Service Bulletin

Bulletin No.: PIT6132D

Subject: Hum Buzz Vibration Type Noise From HVAC When Set To Defrost Or Floor Positions

6727886

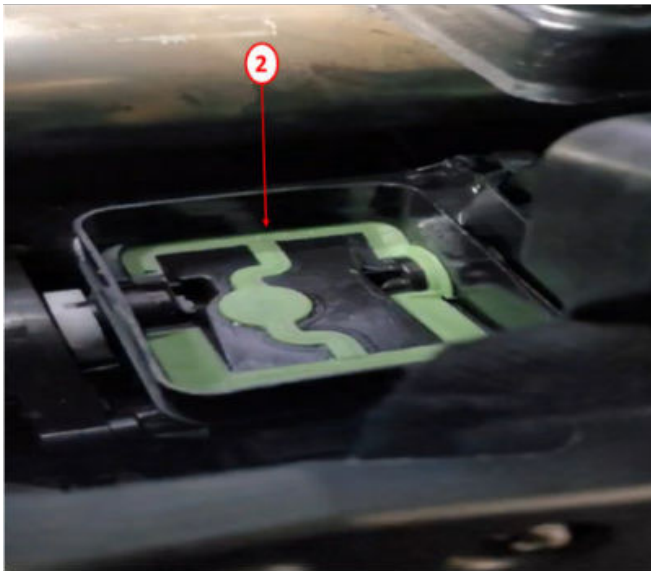
Involved Region or Country	North America
Condition	<p>Some customers may comment of a hum, buzz, or vibration type noise coming from the HVAC when the mode is set to the defrost or floor positions along with higher blower speeds and higher temperature settings. If the HVAC mode is changed to include the instrument panel dash vents the noise will be gone.</p> <p>Note: Replacing the HVAC case will not correct this condition and if the HVAC case is replaced the new case will need the repair shown below to resolve the noise.</p>
Cause	<p>The cause of this concern could be the HVAC instrument panel dash vent door seals (2) vibrating against the HVAC case, shown below. This concern only happens when the HVAC instrument panel dash vent doors (2) are in the closed position along with the HVAC set to a higher temperature and blower speed.</p>

6727888

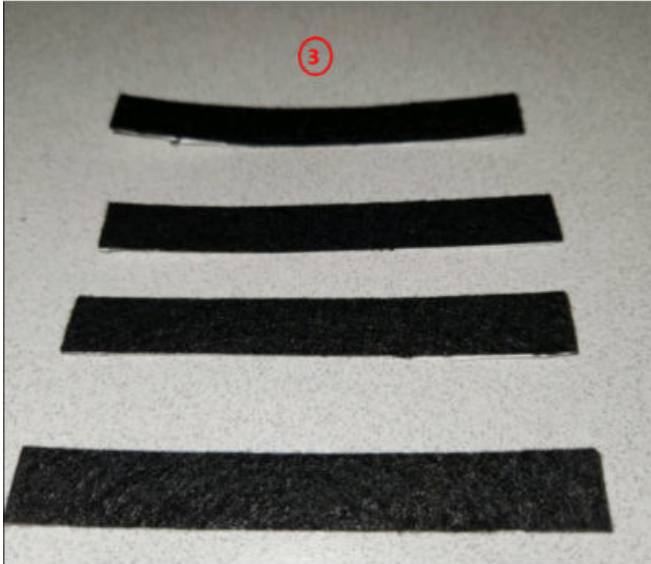
Apply flocking tape (3) to the forward edge of each HVAC instrument panel dash vent duct openings (1) at the door sealing surface (4) where the forward edge of the door contacts the HVAC case.

6727889

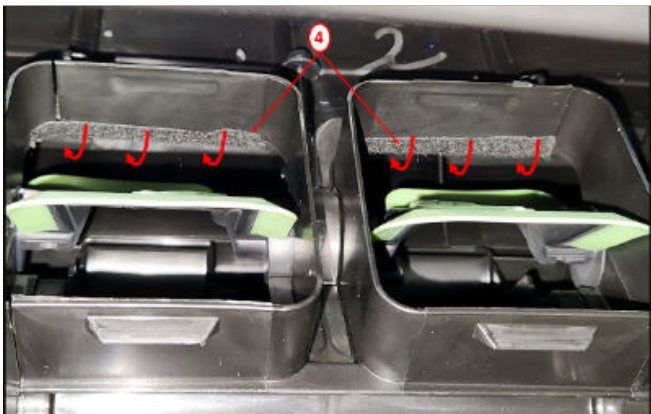
- The tape should be applied to the forward edge of the port with about half of the tape width positioned in the door sealing/contact area and then wrap the remaining tape width up into the port opening, as shown (4). Use an alcohol wipe to clean the HVAC case where the flocking tape will be applied. Apply the flocking tape to the case and use firm pressure to make sure the tape fully adheres to the HVAC case.
- Apply the flocking tape to all 4 instrument panel air outlet duct openings.
- Reassemble the vehicle.
